| AMENDMENT OF SOLICITATION/MODIFICATION OF CONTRACT | | | | 1. CONTRACT ID CODE | | PAGE OF PAGES 1 16 | |
| 2. AMENDMENT/MODIFICATION NO. 003 | | 3. EFFECTIVE DATE 07/16/2010 | | 4. REQUISITION/PURCHASE REQ. NO. NM-10-01640 | | 5. PROJECT NO. (If applicable) | |
| Federal Aviation Administration Acquisition Management Group, ANM-52 1601 Lind Ave SW Renton, WA 98057 | | | | | | | |
| | | | | 9A. AMENDMENT OF SOLICITATION NO. DTFANM-10-R-00045 | | | |

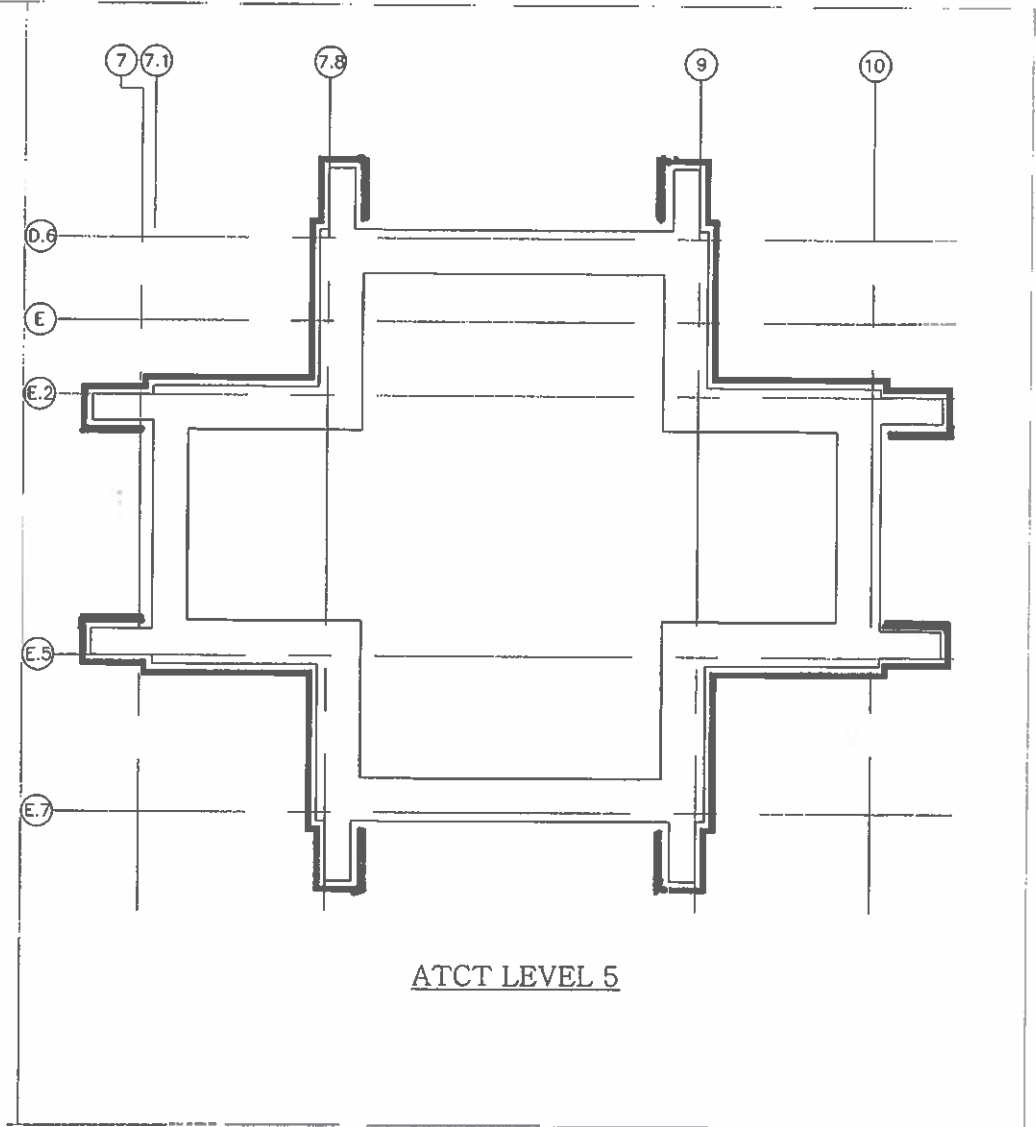
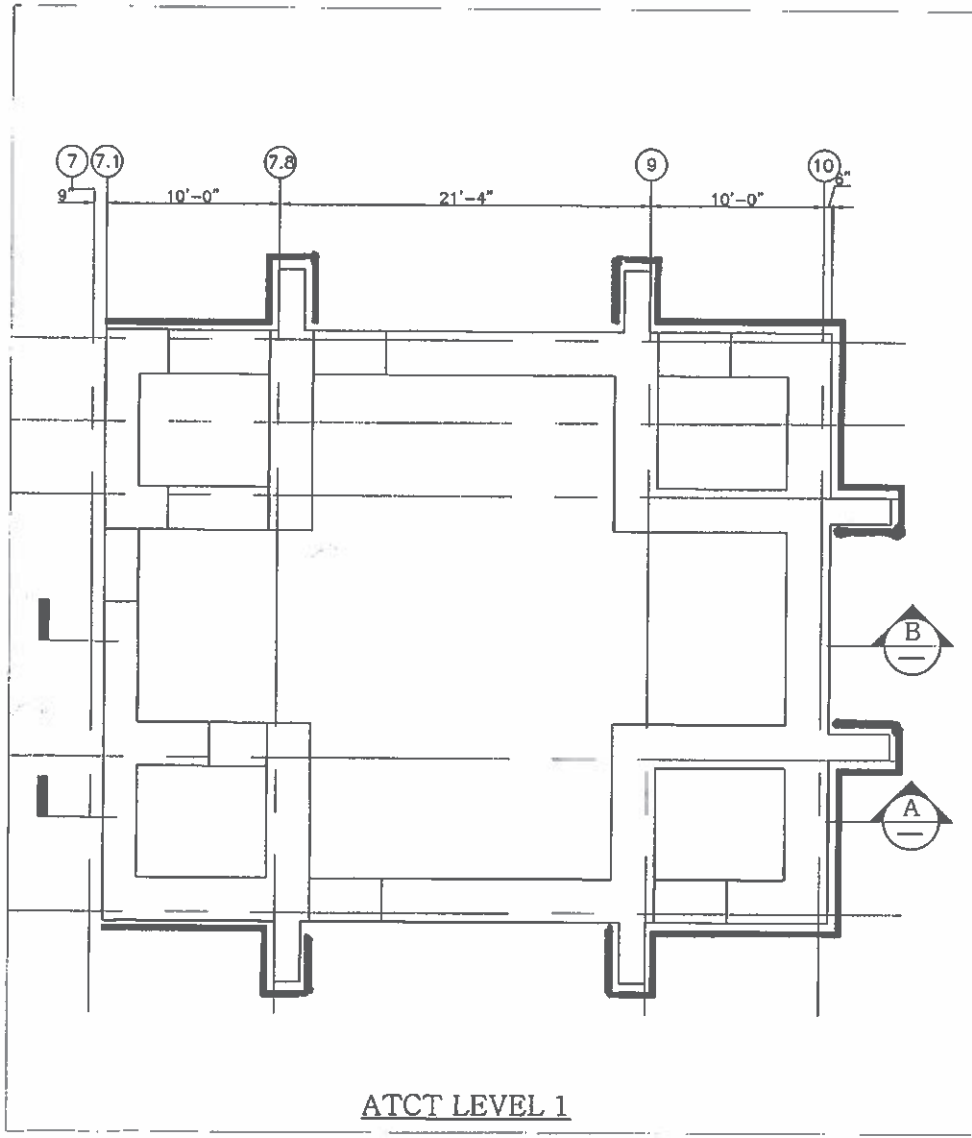
59. Question: Drawing S140 indicates a detail G8/S540 to be used in the retaining wall ramp section. This detail cannot be found on drawing S540. Please provide the detail for bidding use.

60. Question: Drawing S140 along Gridline F near line 1 there is a keyed note that is blank pointing at the wall. Please clarify what this keyed note should be.

Answer: See response to Question No. 20 in Amendment No. 002.

Answer: The keyed note 3 applies to that location.
